CENTERVILLE CITY PLANNING COMMISSION AGENDA

Short Title: Public Hearing - Conceptual Site Plan Amendment, South Davis Metro Fire Station 83

**STAFF REPORT
AGENDA: ITEM 1**

Re: NEW CENTERVILLE FIRE STATION #83 PROPOSED WALK AND LANDSCAPE REVISIONS ALONG MAIN STREET

SP100A

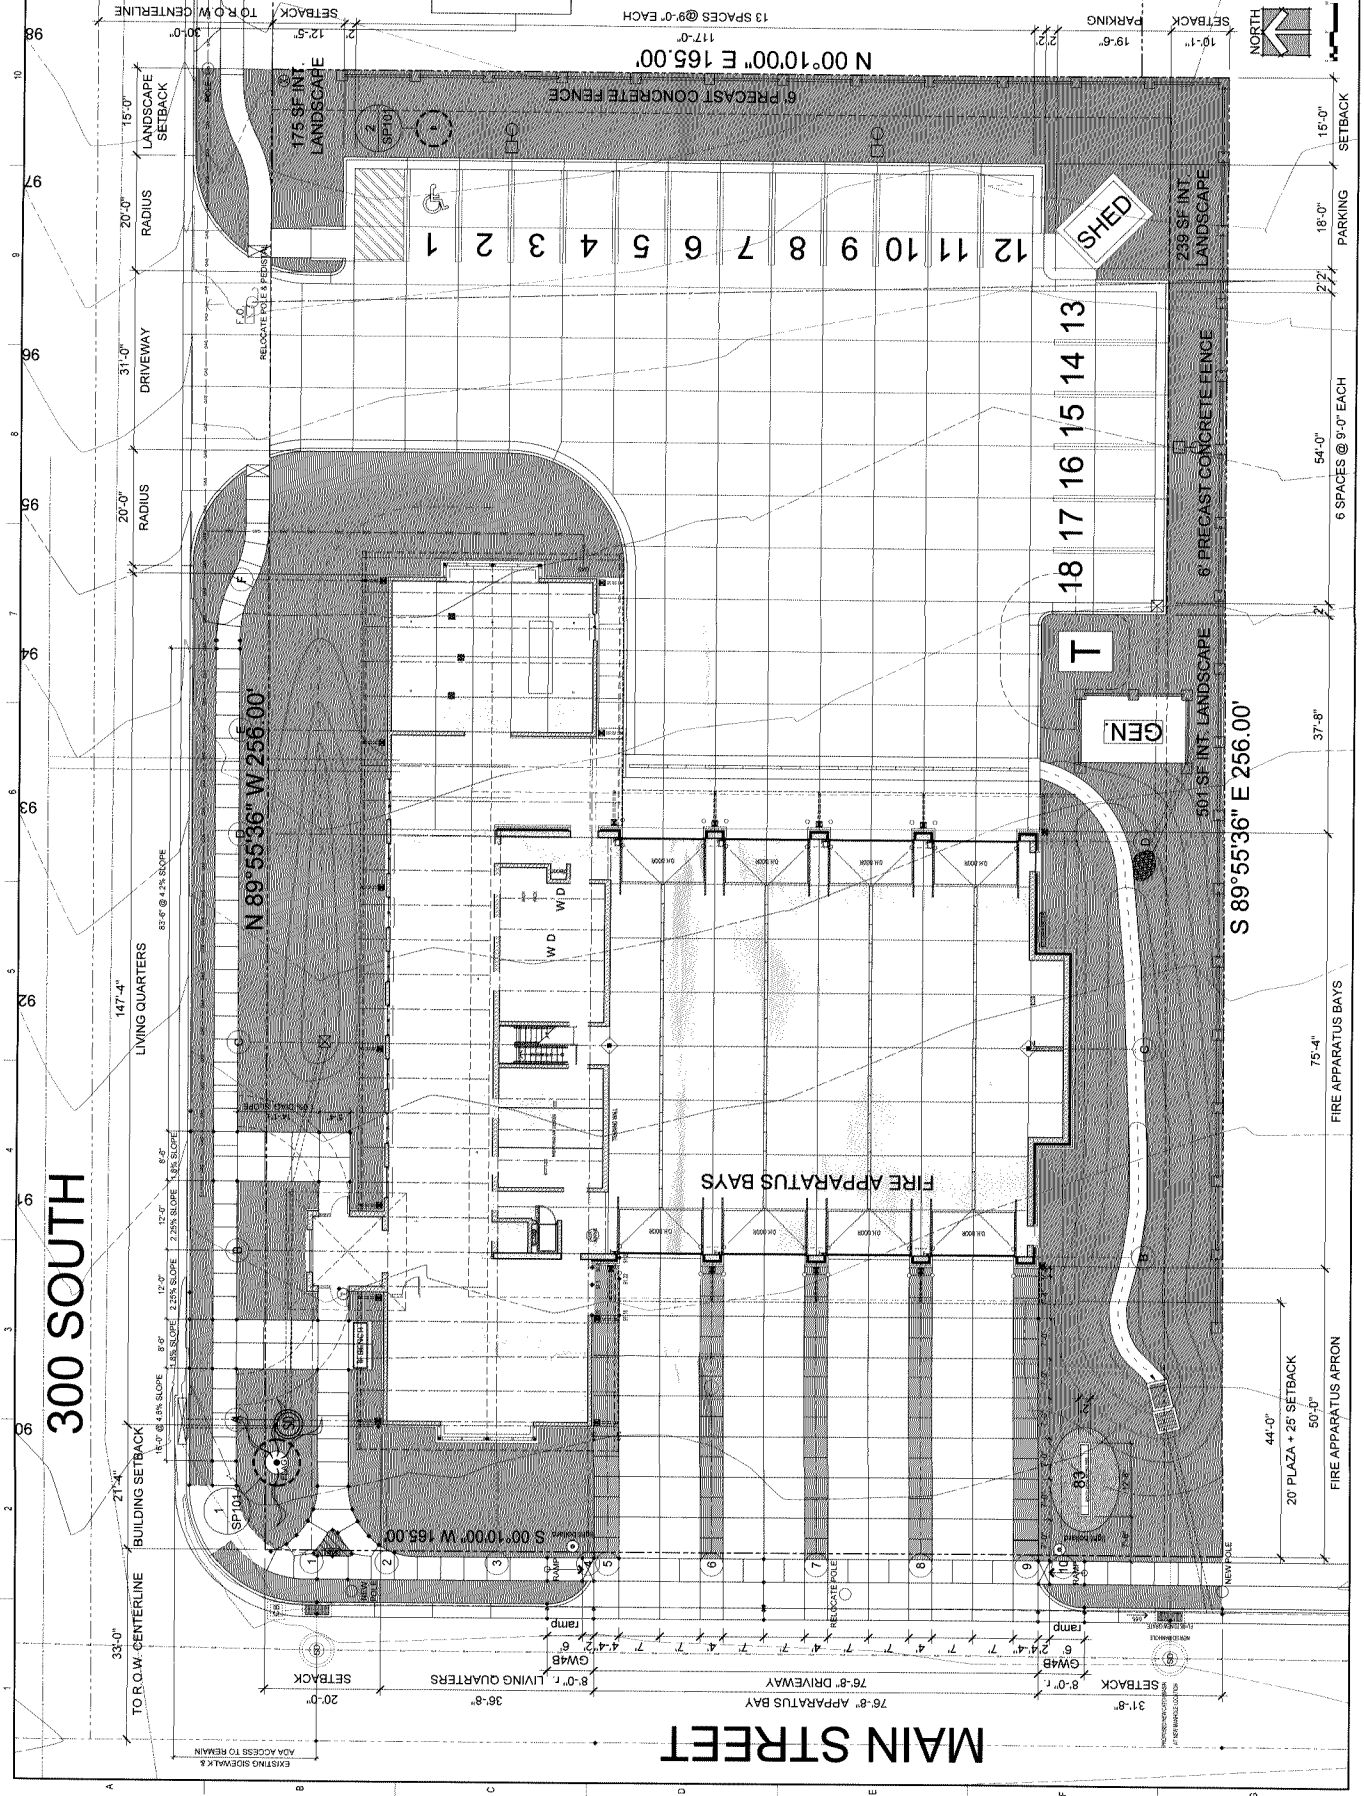
- Main Street Sidewalk/ Building Entrance Alterations – This alternative design eliminates the previous need to obtain a pedestrian easement for the originally meandering sidewalk located outside of the right-of-way. [Positive Support]

- Apparatus Bay, Alternative Design – The original design consisted of various scoring (*i.e. joint lines*) with a particular layout style and incorporated the meandering sidewalk. Now that the bay drive has been dropped to a roadway style approach with ADA drop down ramps, a new design layout was needed. Couple this new with concrete stained drive lane separators and bollard lighting framing the drive approach area, the design is equal to/or exceeds what was originally approved. [Positive Support]

After our meetings with city staff and UDOT, we propose to make the following revisions to our site plan:

MAIN STREET SIDEWALK

- MOVE THE 4' WALK BACK INTO THE STREET RIGHT-OF-WAY.
- ADA TRUNCATED DOMES EACH SIDE OF THE WALK INTERSECTION WITH THE APPARATUS DRIVEWAY
- LIGHT BOLLARD EACH SIDE OF THE DRIVEWAY

APPARATUS BAY DRIVEWAY

- RECTANGULAR SAW-CUTS INSTEAD OF CUVED
- 4' WIDE STAINED CONCRETE BETWEEN BAY DOORS
- BROOMED FINISHED NATURAL CONCRETE IN FRONT OF EACH BAY DOOR

PUBLIC ENTRANCE

- STRAIGHTEN SIDEWALK FROM ENTRANCE TO MAIN STREET - This take the place of a curved walk connecting to the apparatus bay driveway. (The flare at the connection to the Main Street walk is to straddle Utopia's in-ground box.)
- SQUARE UP THE WALKS CONNECTING TO 300 SOUTH
- ADD A PUBLIC BENCH/ARTWORK NEAR THE PUBLIC ENTRANCE

L-1

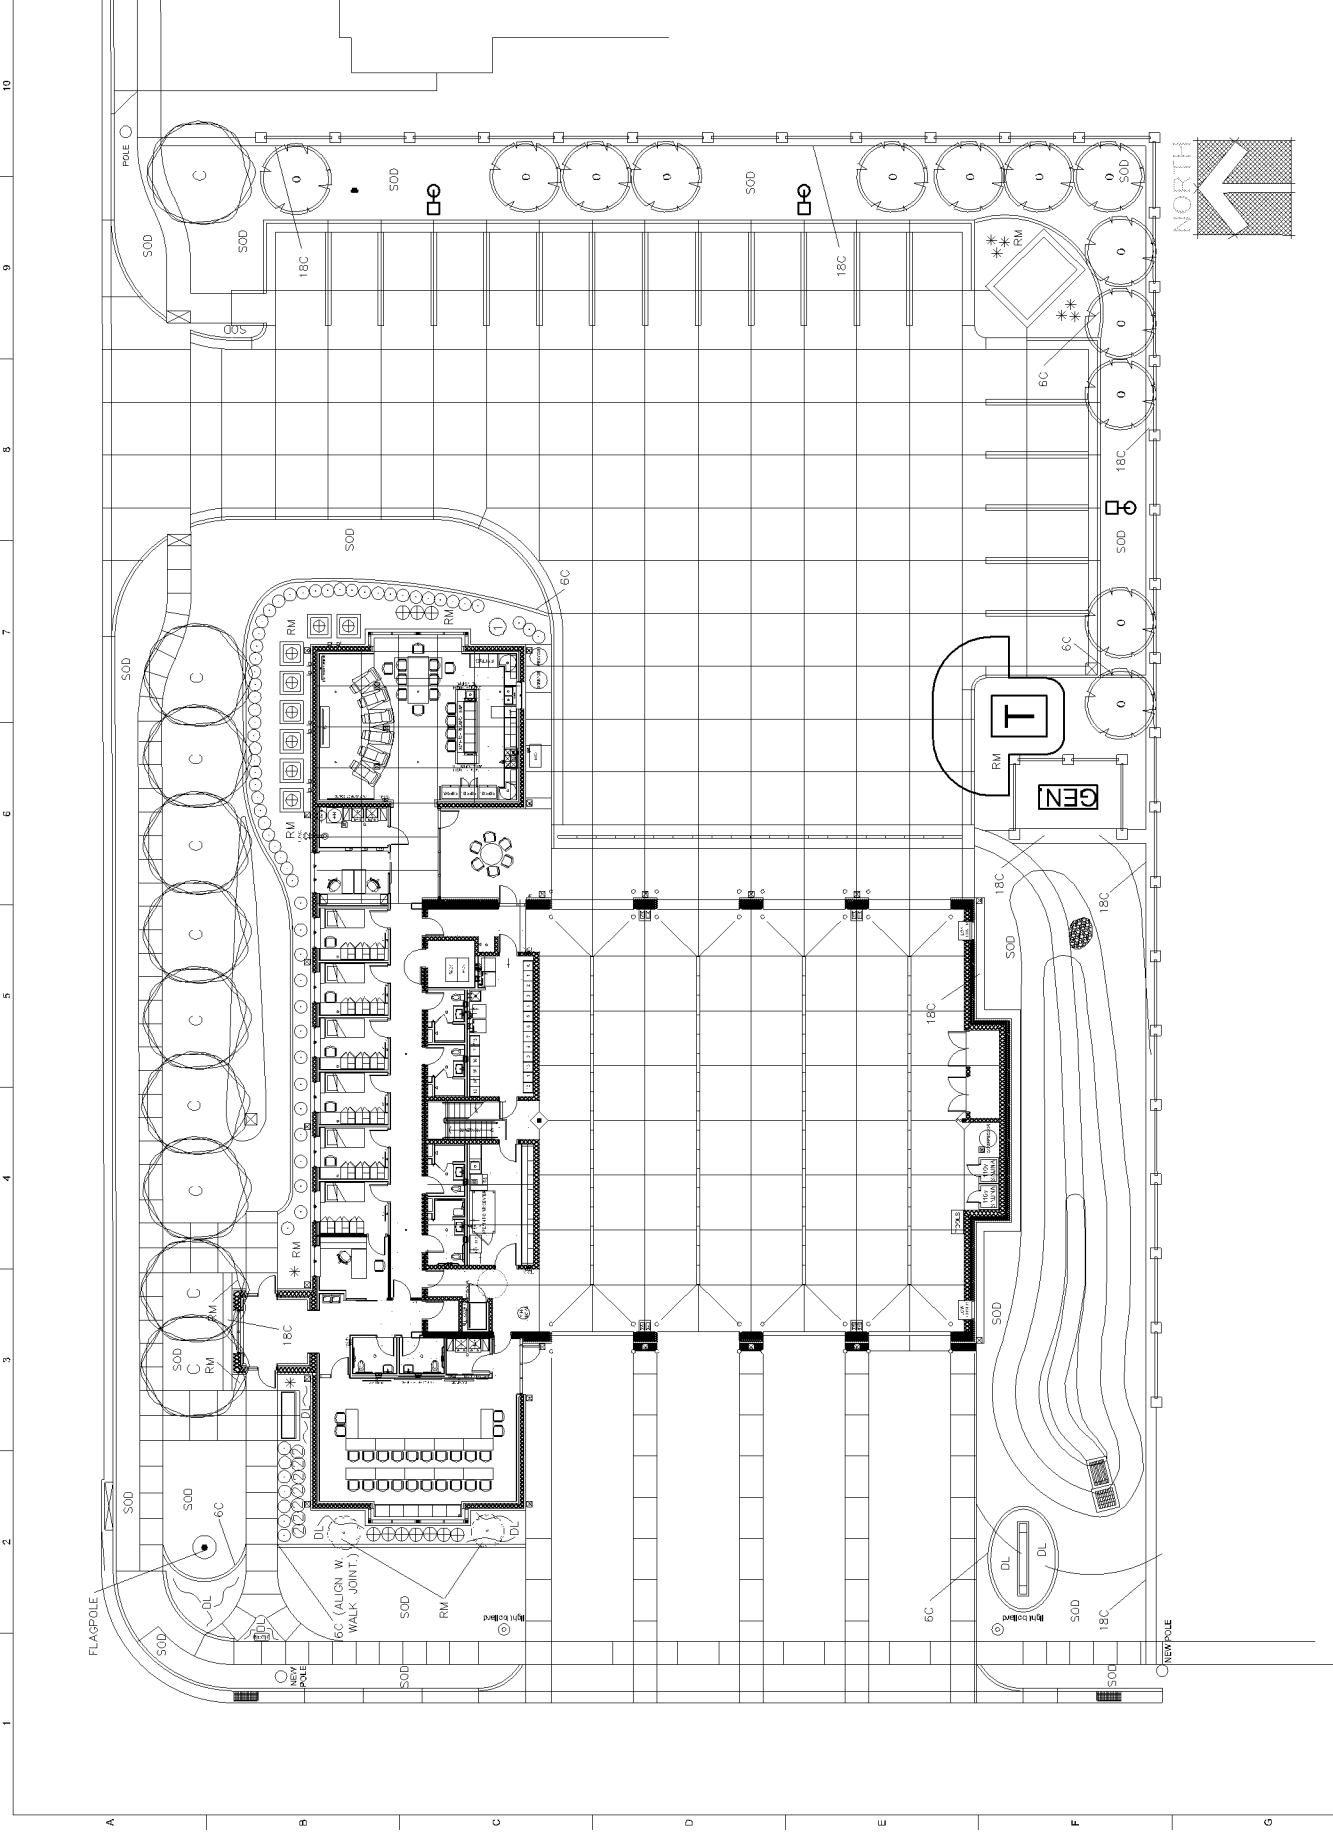
- Landscaping and Gathering Area Re-design – With the Council adopting additional alternatives for the required “gathering space, the new change complies (*see CZC 12.48.100.a.16*).

However, the elimination of required “*street trees*” is an ordinance concern. The Zoning Ordinance requires one (1) tree for every 25 feet of street frontage (*see CZC 12-51- Landscaping, subsection 070. f.2*). This roughly equates to 17 trees for both the 300 South and Main Street frontages of the site.

LANDSCAPE

- LOW SHRUBS, FLOWERS AND GRASS ALONG MAIN STREET SO VIEWS AREN'T BLOCKED - NO TREES ALONG MAIN STREET.
- MONUMENT SIGN SQUARED UP WITH BUILDING
- FLOWER BED AROUND THE MONUMENT SIGN.

The landscape plans are re-issued in their entirety to accommodate the revisions along Main Street, revisions to the building foundation planting and deletion of some planting near the back transformer / generator area.

- ✓ Comply with the ordinance requirements
- ✓ Trees may be substituted by shrubs at a ratio of 10 shrubs to one tree. Shrub size shall be a #5 container with a spread of 18 to 24 inches when installed. Not more than 25% of required trees may be substituted.
 - *The revised landscaping plan depicts 12 trees along the street frontages, one additional tree will be needed to meet the requirement for substitution*
 - *From review of the landscaping, it appears to have a sufficient amount of shrubs to meet the substitution allowance*
- ✓ Apply for a “waiver of strict compliance,” as outline in CZC 12.51.050. The Planning Commission is authorized to allow such waivers, pending the findings listed therein. [*Supportive pending fulfillment of any one of the options listed above*]

1. *The applicant shall prepare and submit a Final Site Plan Application, as described by the Zoning Ordinance.*
As part of the subsequent Final Site Plan submittal, the applicant will need to decide the following regarding landscaping and street tree compliance:
 - a. *Comply with the ordinance requirements*
 - b. *Trees may be substituted by shrubs at a ratio of 10 shrubs to one tree.*
 - i. *Shrub size shall be a #5 container with a spread of 18 to 24 inches when installed.*
 - ii. *Not more than 25% of required trees may be substituted.*
 - c. *Apply for a "waiver of strict compliance," as outline in CZC 12.51.050. The Planning Commission is authorized to allow such waivers, pending the findings listed therein.*
